Groundwater Application Review Summary Form

Application # G- 18715

To: Kristopher Byrd, Well Construction and Compliance Section Manager
From: Joel Jeffery, Well Construction Program Coordinator
Subject: Review of Water Right Application G-18715
Date: August 16, 2018

TO: Water Rights Section Date 8/13/2018
 FROM: Groundwater Section Aurora C Bouchier
 Reviewer's Name
 SUBJECT: Application G- 18715 Supersedes review of NA
 Date of Review(s)

Water-Level Trends in Nearby Wells

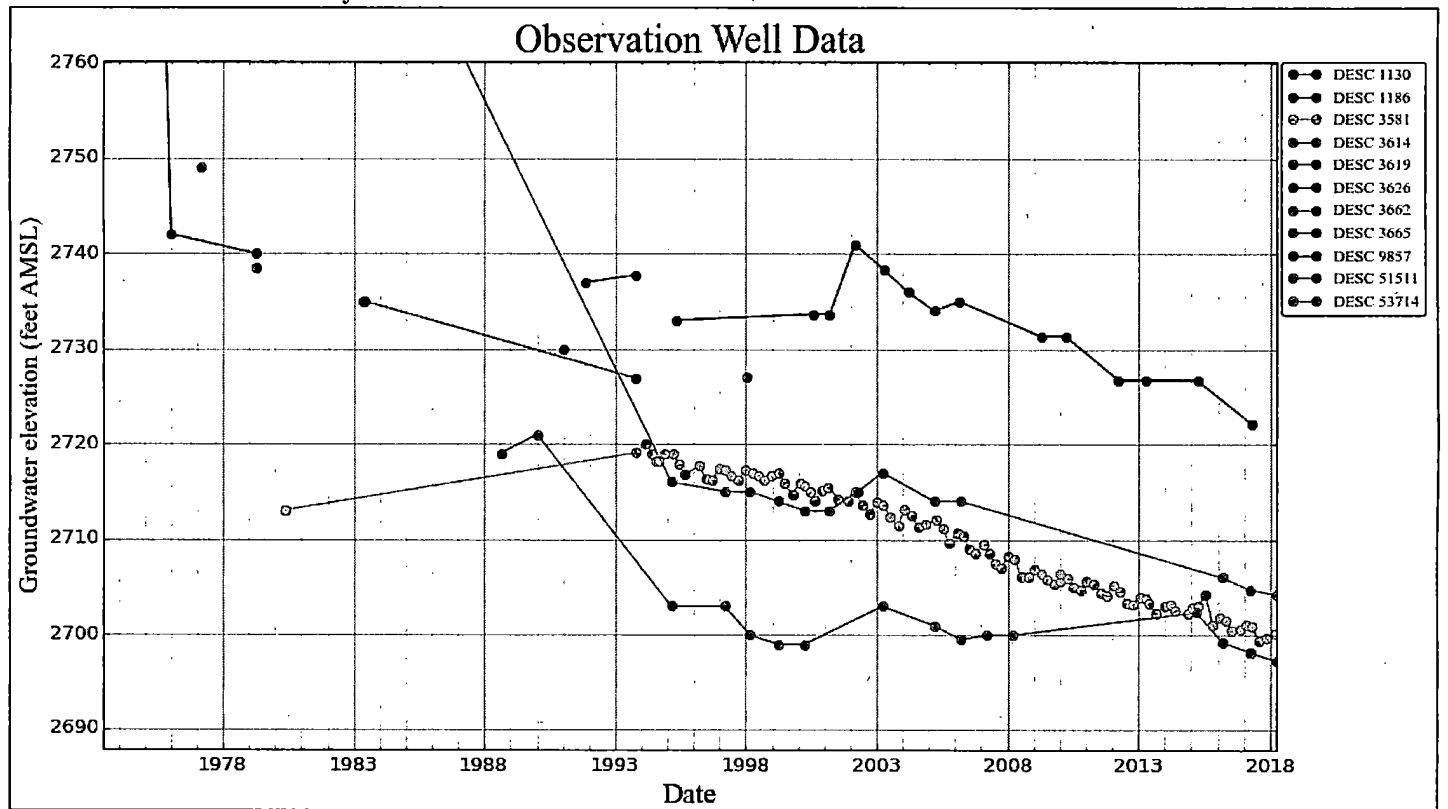
The nearest observation well with similar well depth recently monitored is DESC 3581 (located approximately 1.1 miles to the north-northeast). This well has been measured periodically since the 1970's. The water level trend for this observation well and other wells between Bend and Redmond with similar well construction depths show a declining water level of approximately 10-feet per decade since the early 1990's. The declining water levels have been attributed to decreased recharge (the dominant factor accounting for approximately 60-70% of the measured decline) and increased pumping (accounting for 20-30% of the measured decline) (Gannett and Lite, 2013).
